ADDENDUM

ATTACHED TO AND PART OF M.A.C.H. 3 (GAME GV-109)

GAME AS SHIPPED VARIES FROM THE INSTRUCTION MANUAL AS PRINTED

**INTERFACE BOARD ASSY. (A2)  
PART NO. MA-499**

**INTERFACE BOARD ASSY. (A2), COMPONENT LOCATION**

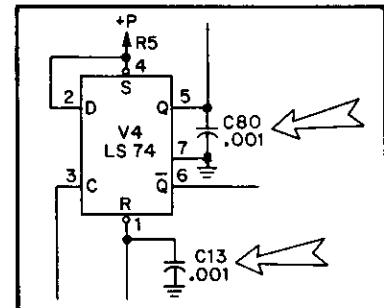
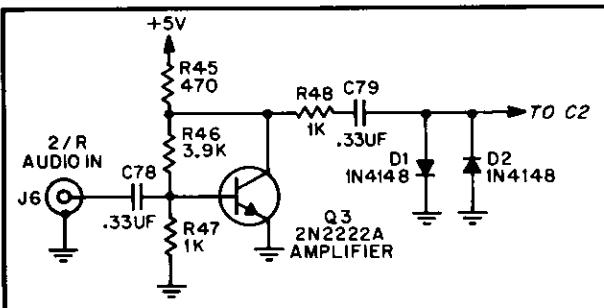
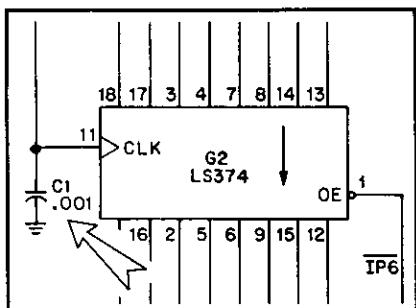
1. Circuit revisions for this assembly have been implemented in this game. The following changes denoted and illustrated below will update pages 38, 39 and 40. Keep this addendum with your instruction manual for future reference.

DELETED:

C32 Capacitor, 820PF, 50V CM-AX, ±80%-20%.....XO-692

ADDED:

C1, C13, C80	Capacitor, .001UF, 50V CM-AX, ±80%-20%.....XO-695
C78, C79	Capacitor, .33UF, 50V CM-AX.....XO-295
D1, D2	Diode, 1N4148.....XO-261
Q3	Transistor, NPN, 2N2222A.....XO-320
R45	Resistor, 470 OHM, 5%, 1/4W.....XO-35
R46	Resistor, 3.9K OHM, 5%, 1/4W.....XO-39
R47, R48	Resistor, 1K OHM, 5%, 1/4W.....XO-5

2. Make the following changes as shown below in the partial illustration to the **PRIMARY POWER/FILTER BOARDS/INTERCONNECTION DIAGRAM** schematic on pages 50, 51 and 52 in the instruction manual:

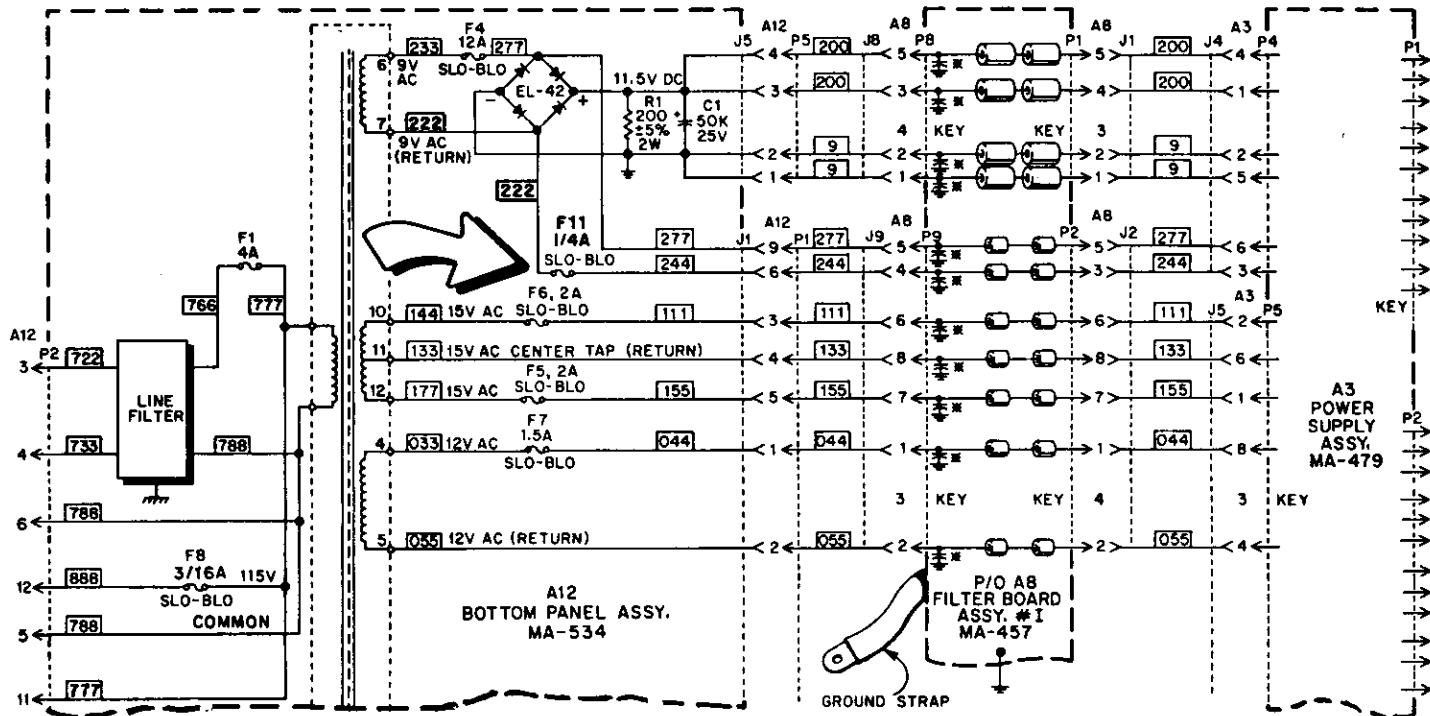
1. Add the following to **VIII. GENERAL INFORMATION--C. FUSES--BOTTOM PANEL** on page 12 of the instruction manual:

F11 9V AC

1/4 Amp SLO-BLO

(a) Add fuse F11 to the 9V AC RETURN line as shown below.

(b) Change wire color 244, between tap 7 (9V AC RETURN) on the transformer and the bridge rectifier, to wire color 222; add wire color 222 from the bridge rectifier to F11, as shown below.
